Reliability Analysis Update

Transmission Expansion Advisory
Committee

February 9, 2017

Project Scope Change - B2557

Existing Scope from Alternative #1

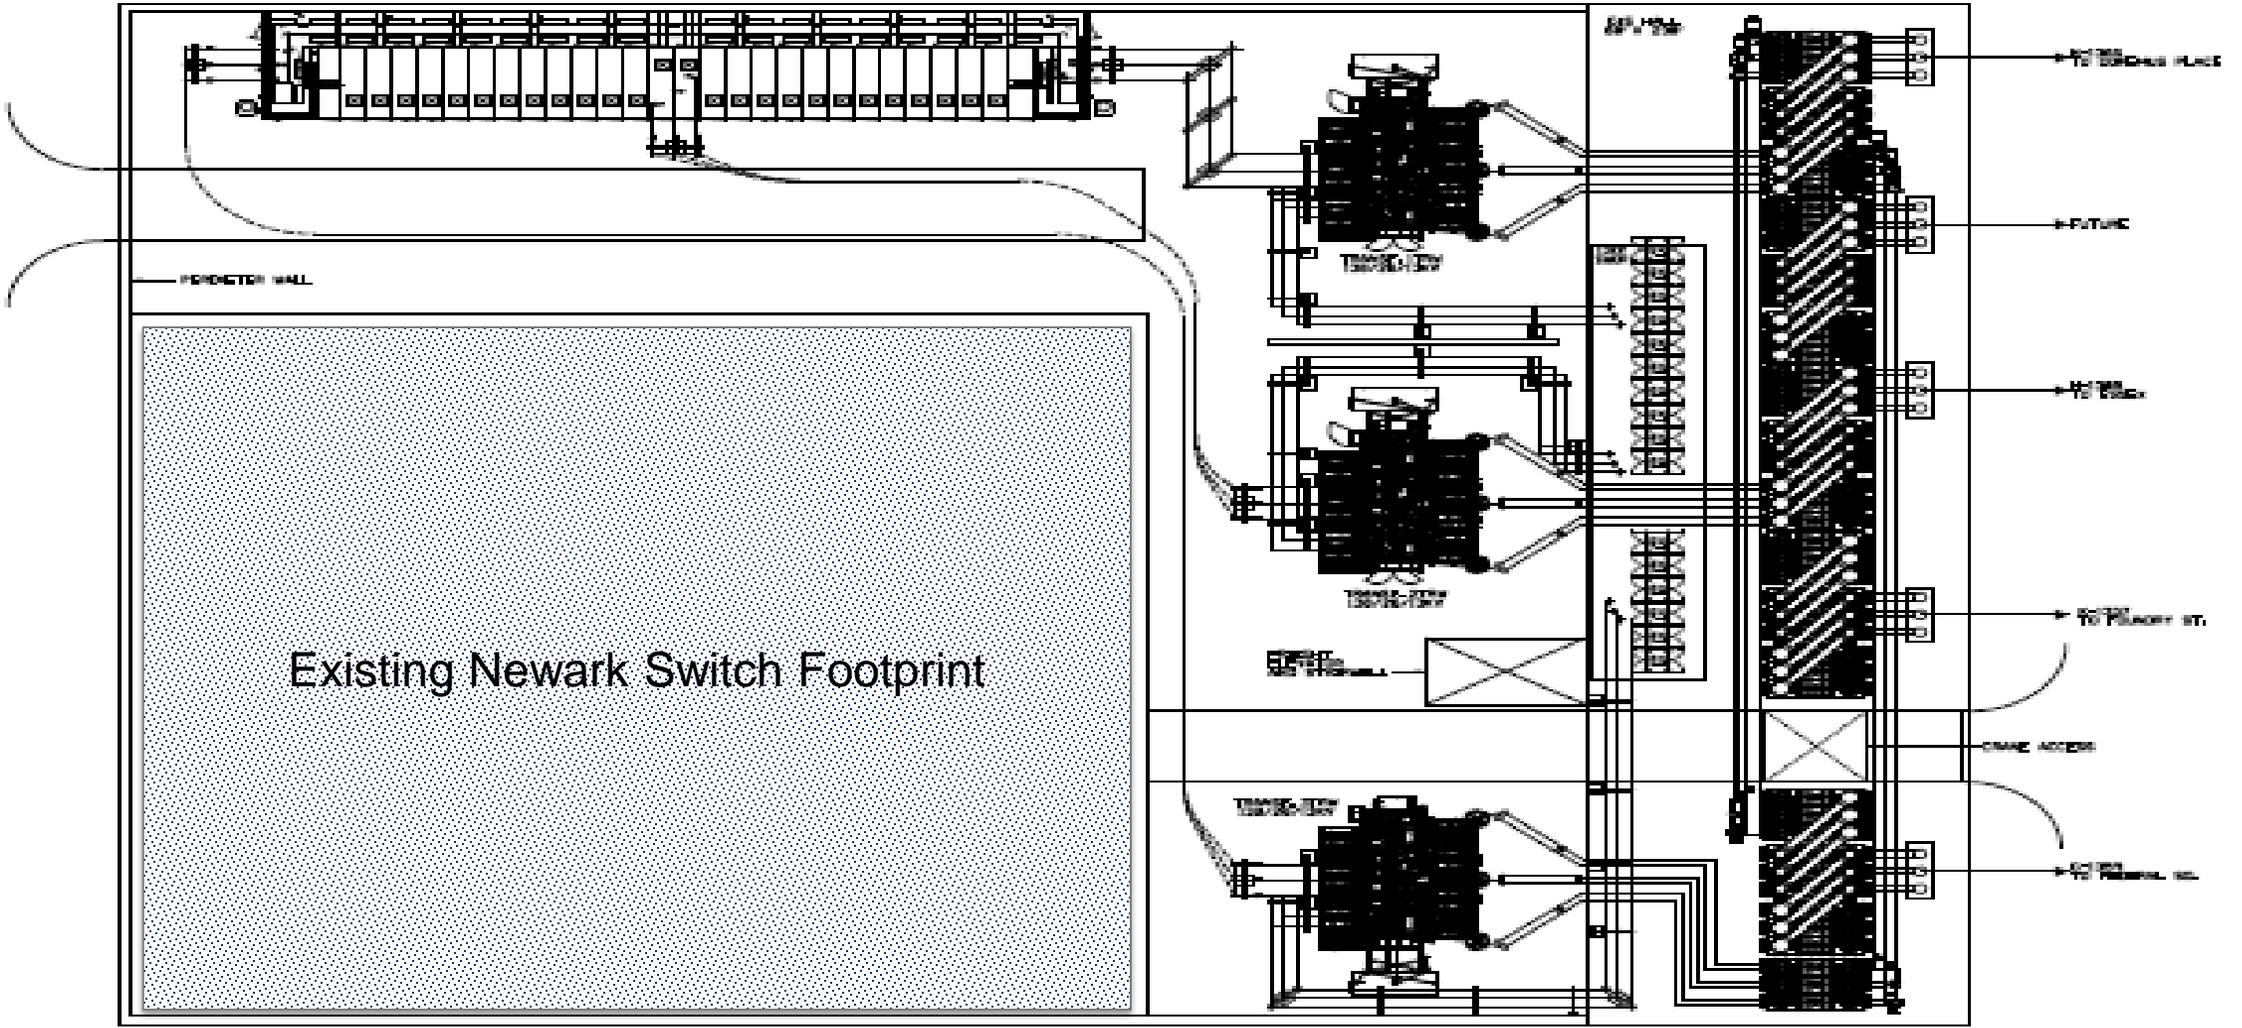
- New layout is five bay breaker and a half GIS on same property
- 13kV feeders would move to new GIS building

- Purchase 3 new dual ratio transformers and place outside of existing building
- 26kV feeders above transformers would move outside on ground level adjacent to new access driveway
- Arrange GIS in compact layout making building narrower, longer and lower
- Build new (3) story building isolated from existing Station building with sub-basement for storm water retention
- GIB is entirely within new building
- 13kV and 26kV feeders are at ground level
- Transformer outages required for cutovers are not as long
- Use conventional demolition methods

PSE&G Transmission Zone Newark Switch New Design Concept

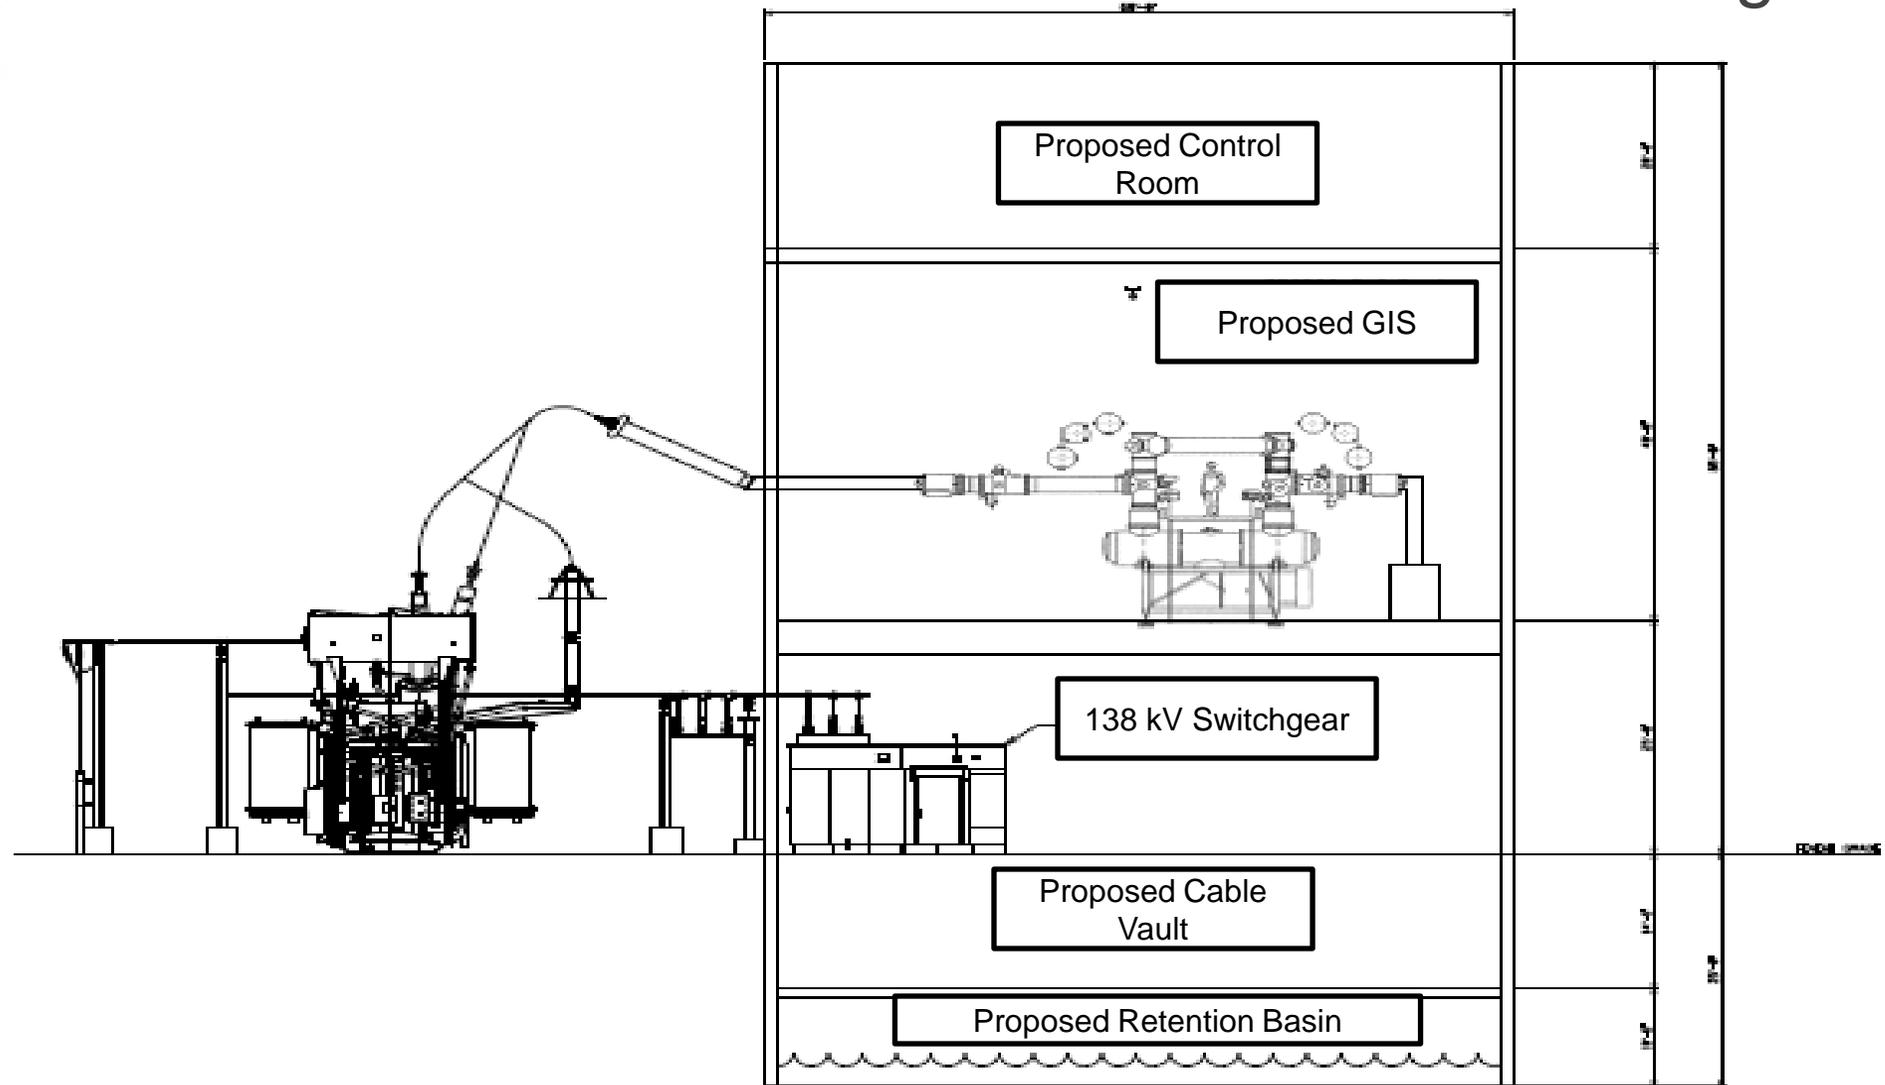
- Alternate 1A new scope & layout has less constructability concerns than the previous alternative 1 approach
 - All new construction is completely outside of existing building

- Work can be done on standard work day schedules, reducing construction productivity risks due to construction during outages (i.e. GIB and transformer bushing work)

- No longer necessary to build GIB over existing transformers
 - Additional property facilitates staging of equipment deliveries
- Transformer arrangement meets standard fire protection criteria and oil-filled cables are no longer next to transformers

- GIB is no longer over energized equipment in existing building
- Transformer outage cutovers are reduced
 - GIS and GIB can be fully tested prior to starting cutovers
